Braidwood Station, Units 1 and 2
Facility Operating License Nos. NPF-72 and NPF-77
NRC Docket Nos. STN 50-456 and STN 50-457

Byron Station, Units 1 and 2
Facility Operating License Nos. NPF-37 and NPF-66
NRC Docket Nos. STN 50-454 and STN 50-455

Subject: Additional Information Supporting License Amendment Request to
Revise Technical Specifications (TS) for Steam Generator
Permanent Alternate Repair Criteria

**Response to
NRC Request for Additional Information on H*; RAI #4;
Model F and Model D5 Steam Generators**

Figure RAI4-2
Unit Cell Model and Loading Sequence

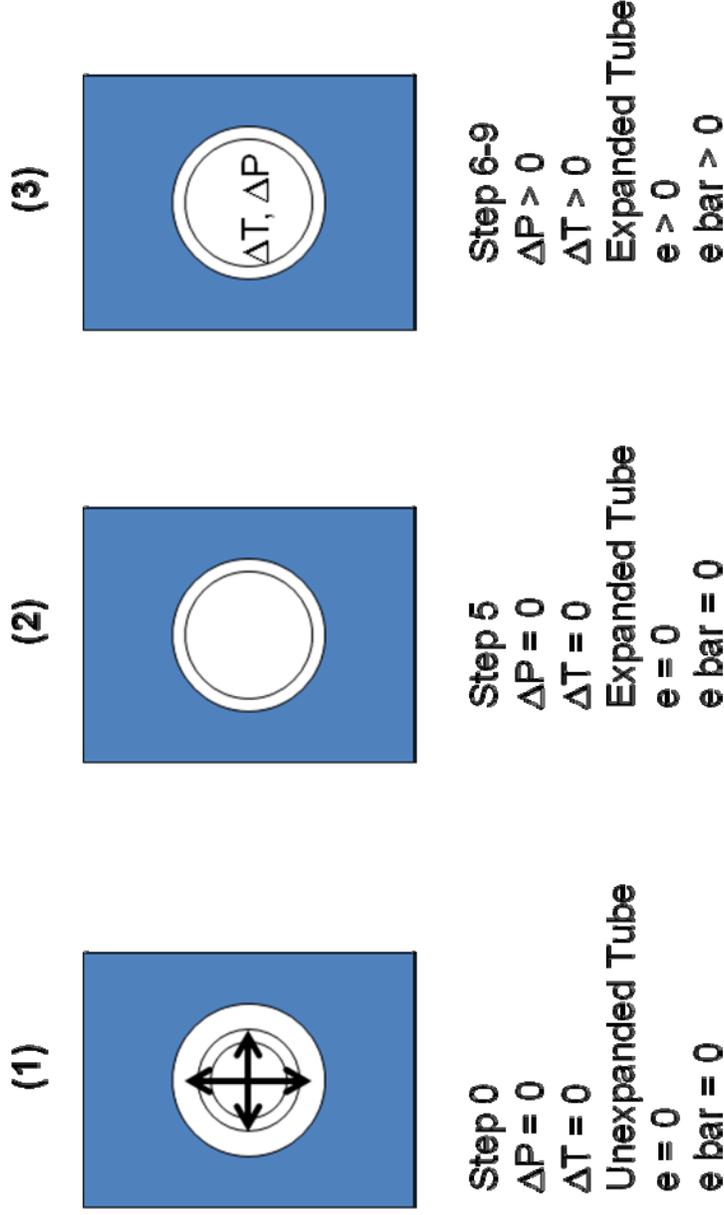
4. *Provide the calculation basis for the upper and lower curves provided in Figure RAI 4-2. (See Section 2.1)*
5. *Resolve the apparent inconsistency between Item 4 on page 25 and the statement below Figure RAI4-1 regarding how the model in Figure RAI4-1 is loaded. (See Section 1.2)*

Resolve the apparent inconsistency between Item 4 on page 25 and the statement below Figure RAI4-1 regarding how the model in Figure RAI4-1 is loaded.

1. The U_R used in the calculation of the circumferential and radial ΔD is based on the linearly scaled 2D axisymmetric FEA model (3-D model for the current H^* analysis) of the lower SG complex
2. The circumferential and radial ΔD 's are used in the scale factor (SF) equation to determine the ΔD_{hole} (see equation RAI4-1) that is used to determine the reduction in contact pressure as a function of eccentricity (e), equation RAI4-2.
3. The relationship between 11D and e is based on the 2-D plane model shown in Figure 6-9 of SM-94-58, Rev.1.

4. The model in Figure 6-9 of SM-94-58, Rev.1 includes the initial applied eccentricities ($D_{MAX} - D_{MIN}$) geometry definition of the model.
5. The “slice” model provides the input for using the SF relationship (Eqn. RAI4-1). The SF is determined by comparing the “slice” model results to the axisymmetric model results for a TS collar and tube model at a given radius in the TS over the full thickness of the TS.
6. The result is then used to calculate the reduction in contact pressure as a function of TS elevation and radius due to TS displacement and tube bore eccentricity. This is appropriate because the conditions for the Model F SG and Model D5 SG (NOP and FLB conditions) are within the range of data for which the scale factor relationship is applicable.

3. The relationship between ΔD and e is based on the 2-D []^{a,c,e} model shown in WCAP-17071-P and WCAP-17072-P, section 6.2.5. The model is shown in Figure 6-49 of the WCAP reports. The range of eccentricity used in this study conservatively exceeds the values of tube bore eccentricity calculated from the perforated TS model in Section 6.2.4.

4. The model in Figure 6-49 of the H* WCAP reports applies boundary conditions to the outer edge of the tube pitch material and does not directly affect the material that is deforming in the tube and tubesheet cell.
